April 17, 1990
NLR-N90086

ADDITIONAL INFORMATION REGARDING
PSE&G'S RESPONSE TO GENERIC LETTER 88-11
DOCKET NO. 50-354
HOPE CREEK GENERATING STATION

Subject: CLARIFICATION OF CONCLUSIONS IN GE RESPONSE TO
GENERIC LETTER 88-11 FOR HOPE CREEK

Figure 3.4.6.1-1

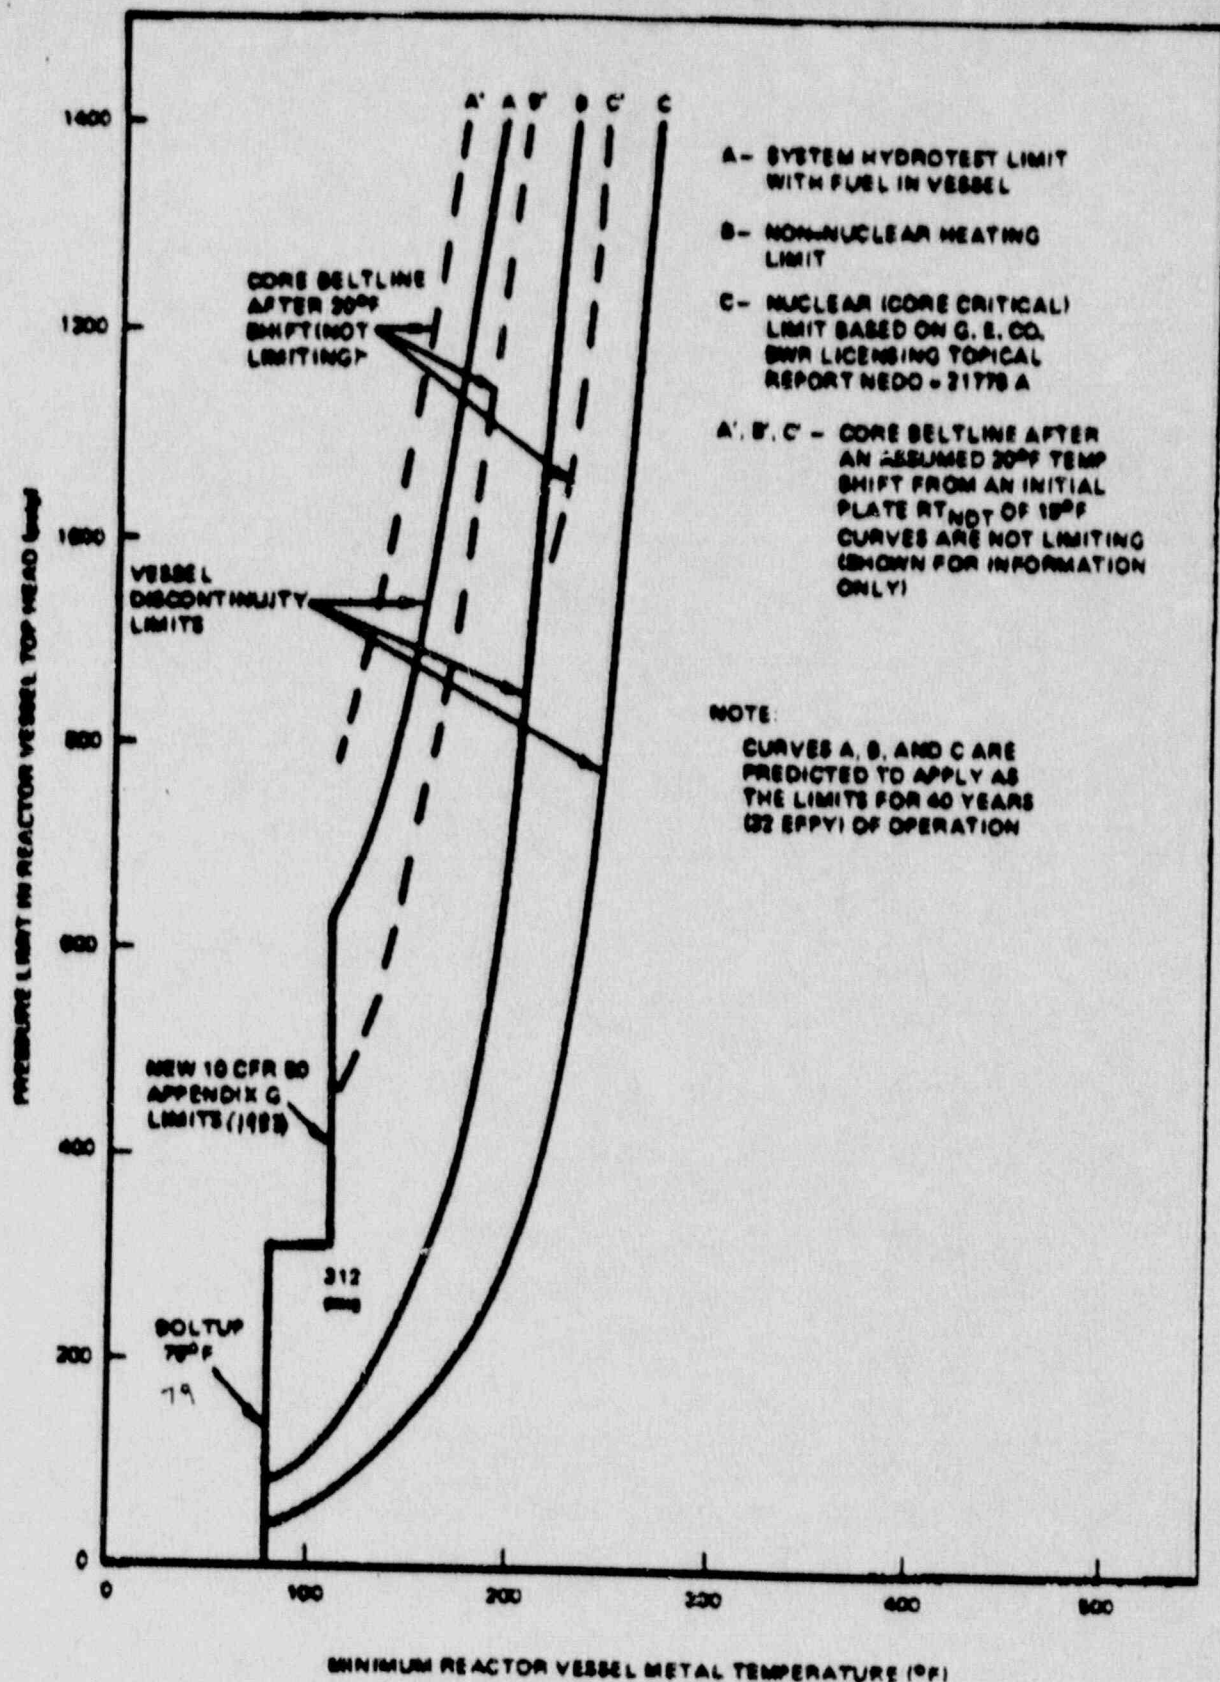
As we have discussed by phone, NRC review of your Generic Letter 88-11 submittal has resulted in a question on one of the conclusions on the period of validity of the pressure-temperature (P-T) curves. The submittal stated that the curves, valid to 32 EFPY using 1.99, Revision 1, were only valid for 6.7 EFPY using 1.99, Revision 2. The NRC reviewer concluded that, even with 1.99, Revision 2, the curves are still valid for 32 EFPY. The statement in the submittal is clarified below. I agree with the NRC's assessment; the current Tech Spec curves are valid for 32 EFPY using 1.99, Revision 2.

The current P-T curves are attached. As seen, curves A', B' and C' are the beltline limits including 20°F shift, which corresponds to the 1.99, Revision 1 shift for 32 EFPY. The figure also notes that A, B and C are more limiting and are therefore the applicable P-T limits for 32 EFPY. In the 88-11 submittal, the conclusion that the P-T curves are valid for 6.7 EFPY referred to curve A', B' and C'. In other words, the shift of 20°F shown in the figure is only valid for 6.7 EFPY using 1.99, Revision 2. After that, the A', B' and C' curves would have to shift further to the right to be correct.

The 88-11 submittal did not address the period of validity of curves A, B and C, which would be more than 6.7 EFPY. As has already been suggested by the NRC review, if the A', B' and C' curves are shifted to cover the limiting conditions using 1.99, Revision 2 (66°F adjusted reference temperature instead of 39°F), curves A, B and C are still limiting. Therefore, the current Tech Spec limits are valid for 32 EFPY using 1.99, Revision 2 methods. Changes required to the P-T curves are only cosmetic, such as moving the A', B' and C' curves as appropriate. Furthermore, the changes do not need to be done before two fuel cycles are completed, because the Hope Creek P-T curves are conservative.
